# ADDENDUM NO. 1

DATE: May 22, 2020  
TO: ALL PLAN HOLDERS  
FROM: Aaron Kiesau – OMNNI Associates, Inc.  
SUBJECT: Appleton International Airport Terminal Expansion Project

**ATW South Maintenance Hangar Reroof  
Alternate #1  
Existing photographs**

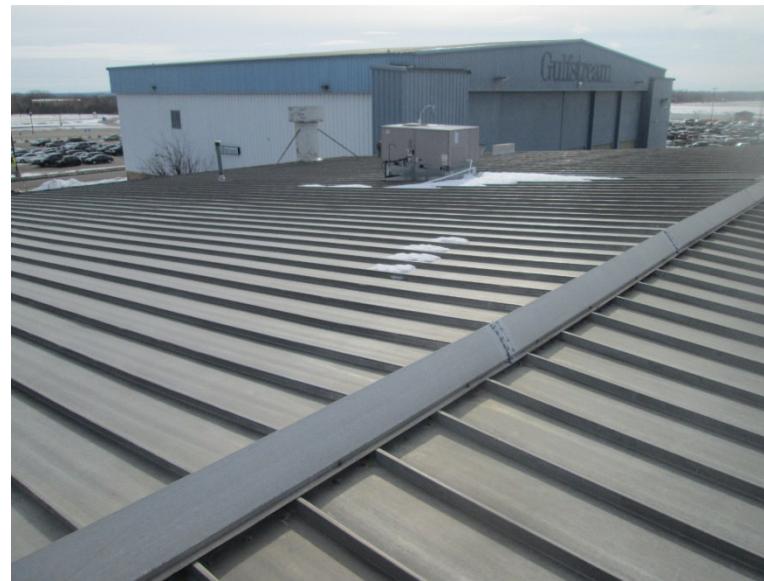
- a. Photos of the existing roof are attached.
- b. Contractor shall be responsible to file the FAA 7460 airspace review with the FAA for the crane usage at the South Maintenance Hangar building within 1 week of the award of a contract. OMNNI can provide coordinates and elevation if the contractor requests them.
